ADDENDUM

ADDENDUM NO.: 03
PROJECT NAME: Minnie Mars Jamieson Elementary School Annex and Renovation
PROJECT NO.: 05760
CONTRACT NO.: C1567
DATE OF ISSUE: May 20, 2015

NOTICE OF CHANGES, MODIFICATIONS, OR CLARIFICATIONS TO CONTRACT DOCUMENTS

Sheet: **A6.0**

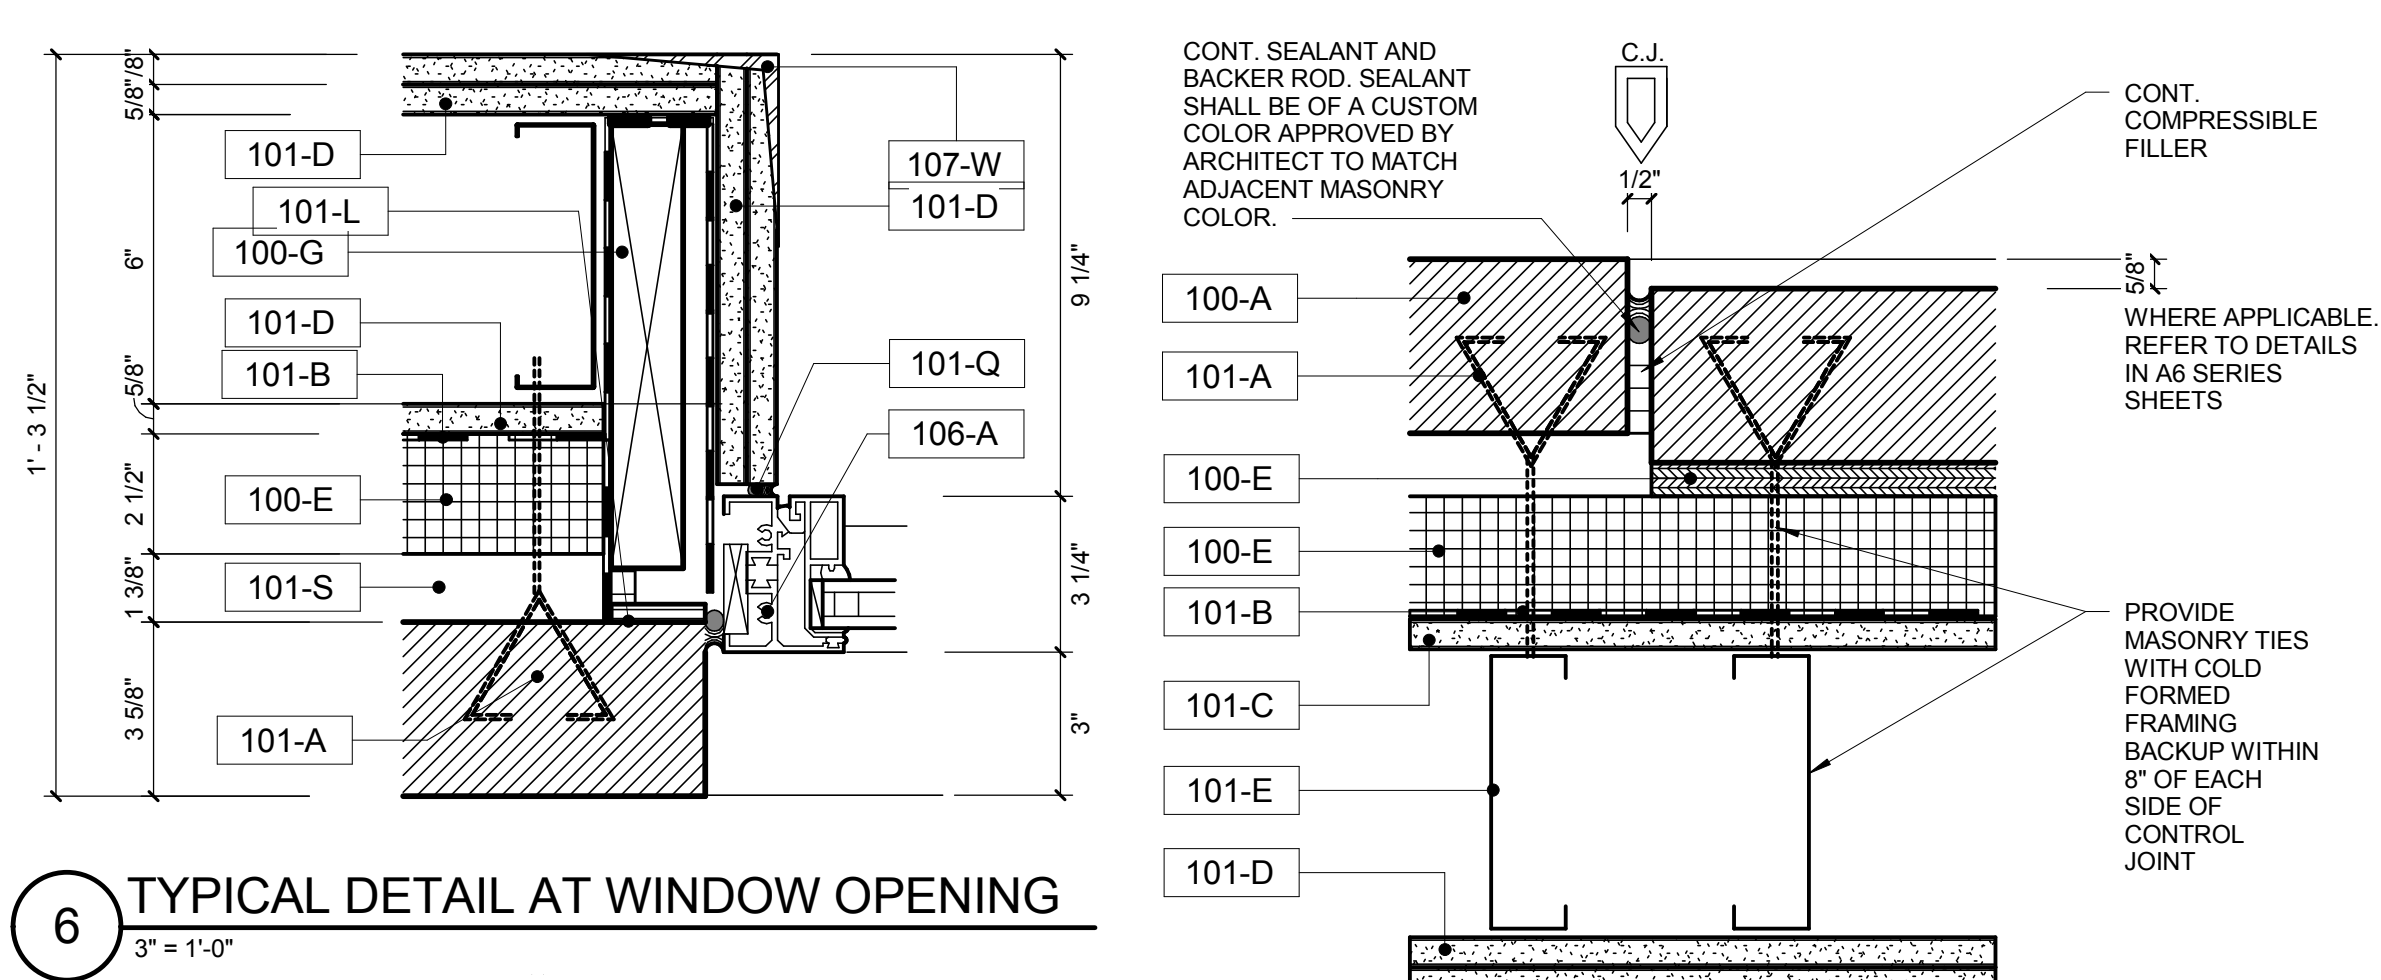
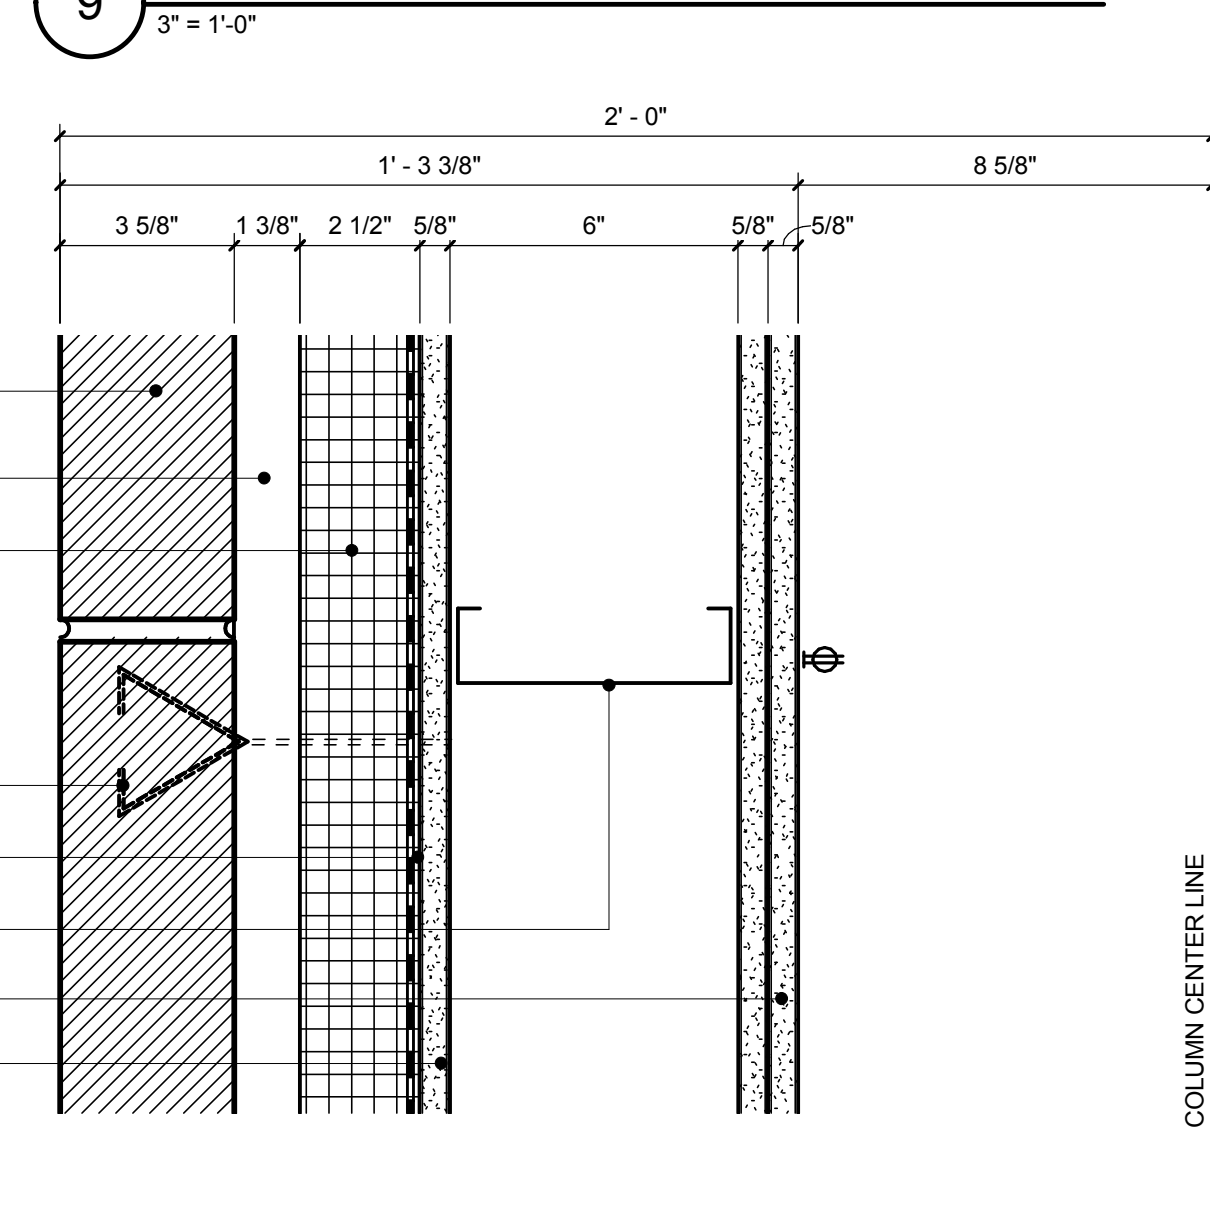
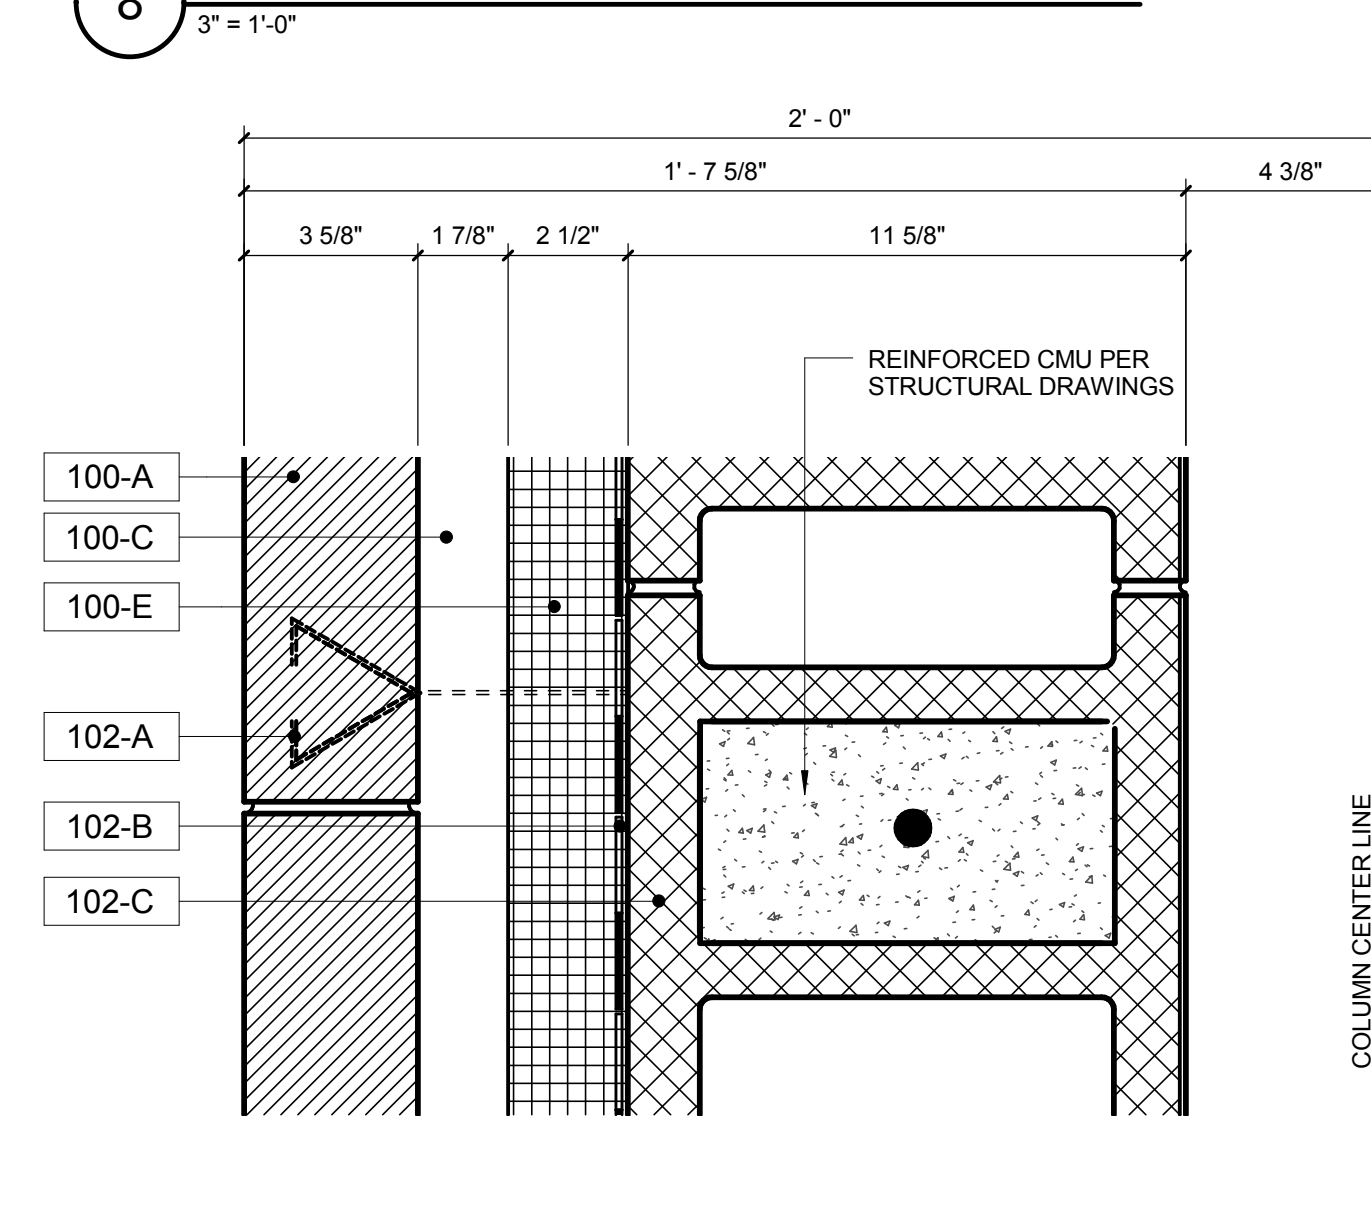
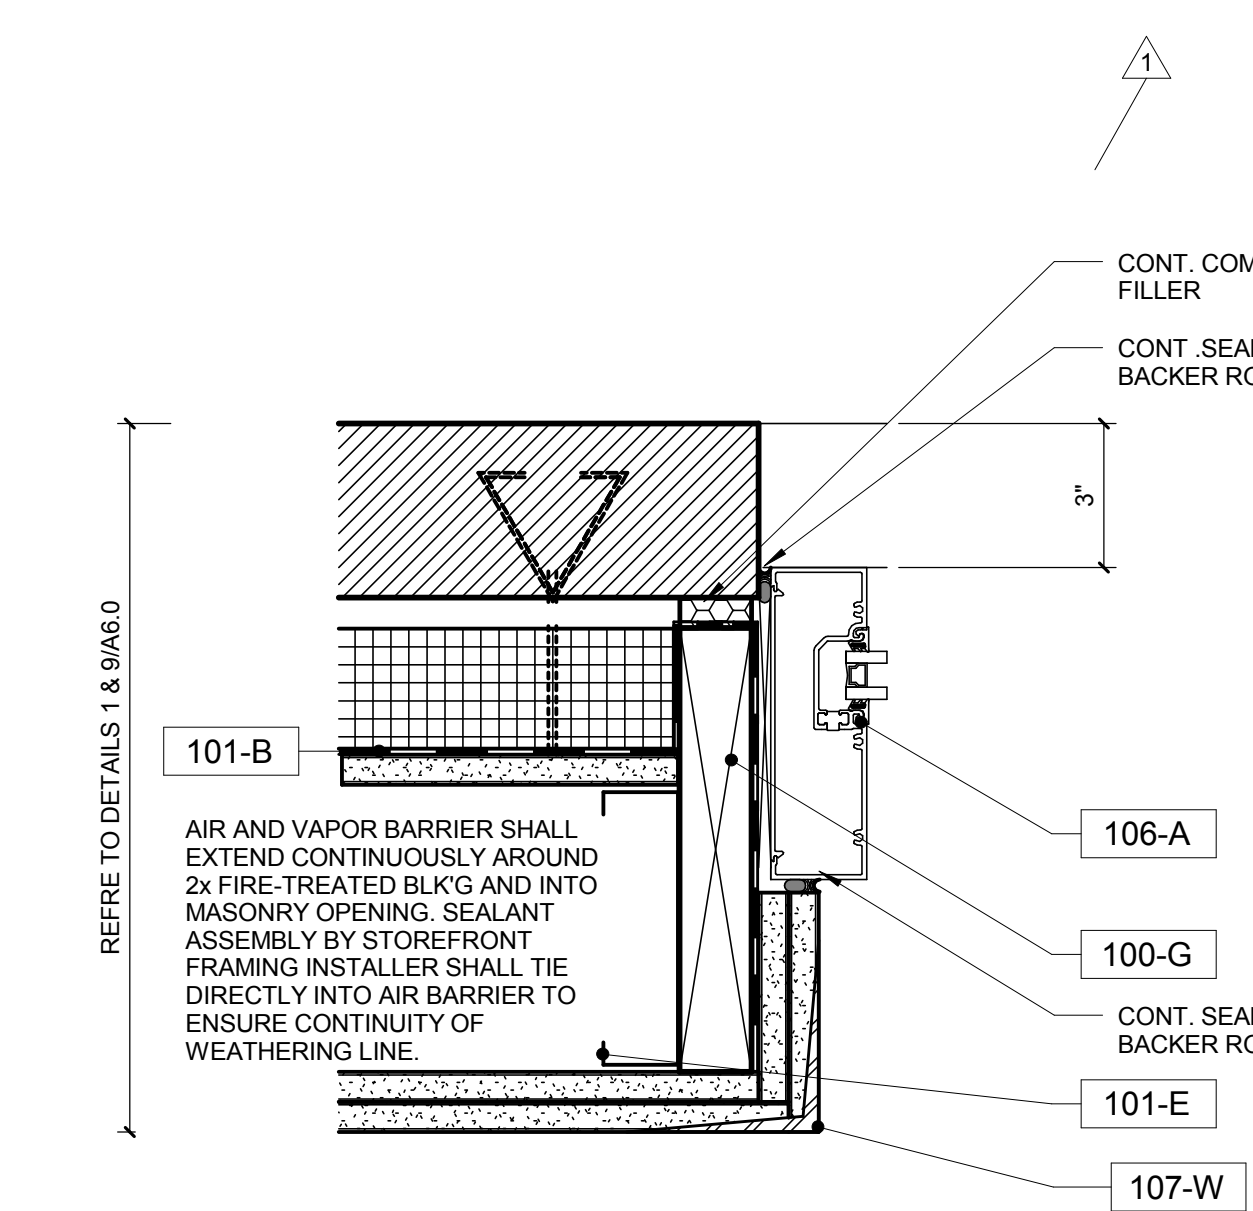
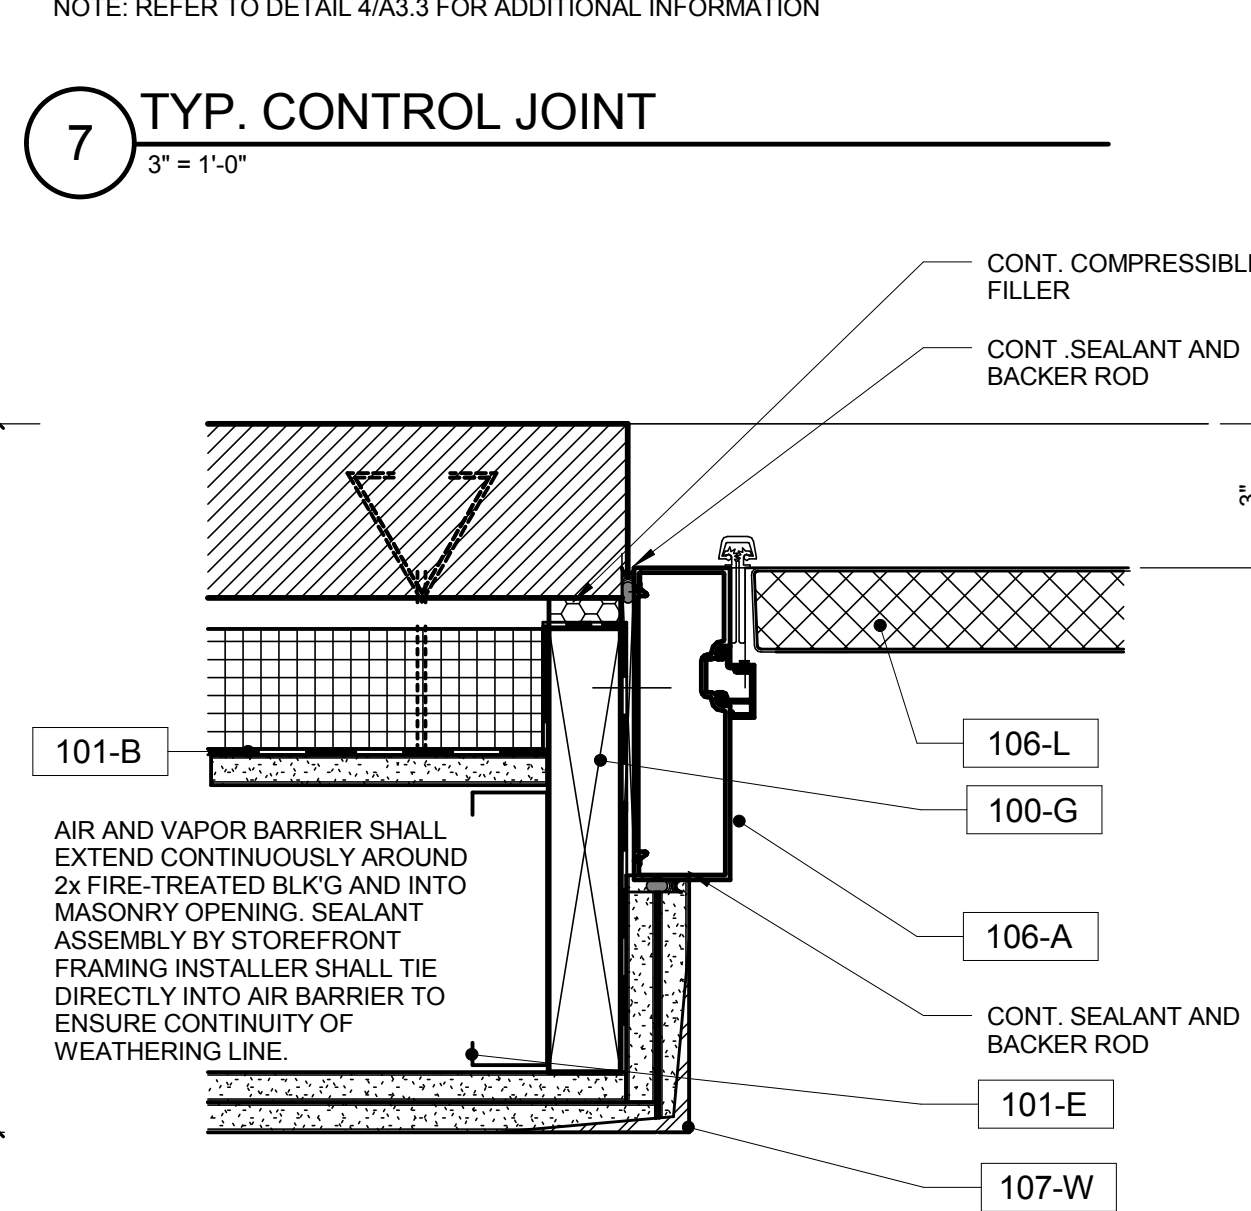
- Change 1. Drawing Sheet A6.0 ENLARGED PLAN KEYNOTES AND TYPICAL CONSTRUCTION:**
ADD Keynotes
ADD Revision 3 mark and dated 05/19/2015, attached.
- Change 2. Drawing Sheet S1.2A SECOND FLOOR FRAMING PLAN:**
REVISE Keynote 1 to define (20 GA) thickness for composite steel deck.
REVISE Keynote 3 to define (20 GA) thickness for composite steel deck.
ADD Revision 3 mark and dated 05/19/2015
***NARRATIVE ONLY, DRAWING NOT RE-ISSUED**
- Change 3. Drawing Sheet S1.3A THIRD FLOOR FRAMING PLAN:**
REVISE Keynote 1 to define (20 GA) thickness for composite steel deck.
REVISE Keynote 2 to define (20 GA) thickness for composite steel deck.
***NARRATIVE ONLY, DRAWING NOT RE-ISSUED**

- RFI-1** On Sheet A6.1 – details 1-3, 4-5 and 8 show a keynote 107-X. There is no 107-X keynote on sheet A6.0. Please advise.

RESPONSE: Information for Keynote 107-V, 107-W, and 107-X have been added to drawing A6.0.

107-U	MECHANICAL DIFFUSERS. REFER TO MECHANICAL DRAWINGS.
107-V	HIGH STRENGTH CORNER BEAD TO BE USED BY SEFT FORME OR APPROVAL EQUAL. PROVIDE HIGH-STRENGTH CORNERS ON ALL EXPOSED OUTSIDE WALL CORNERS.
107-W	ELECTRICAL FIXTURES. REFER TO ELECTRICAL DRAWINGS. FIXTURES + INSTALLATION SHOWN DIAGRAMMATICALLY ONLY.
107-X	CLOSE THE VOID BETWEEN PARTITION AND UNDERSIDE OF DECK WITH MINERAL WOOL (SAFING INSULATION) AND FIRE BARRIER SEALANT WITH AN 1-HOUR RATING U.L. APPROVED SYSTEM.
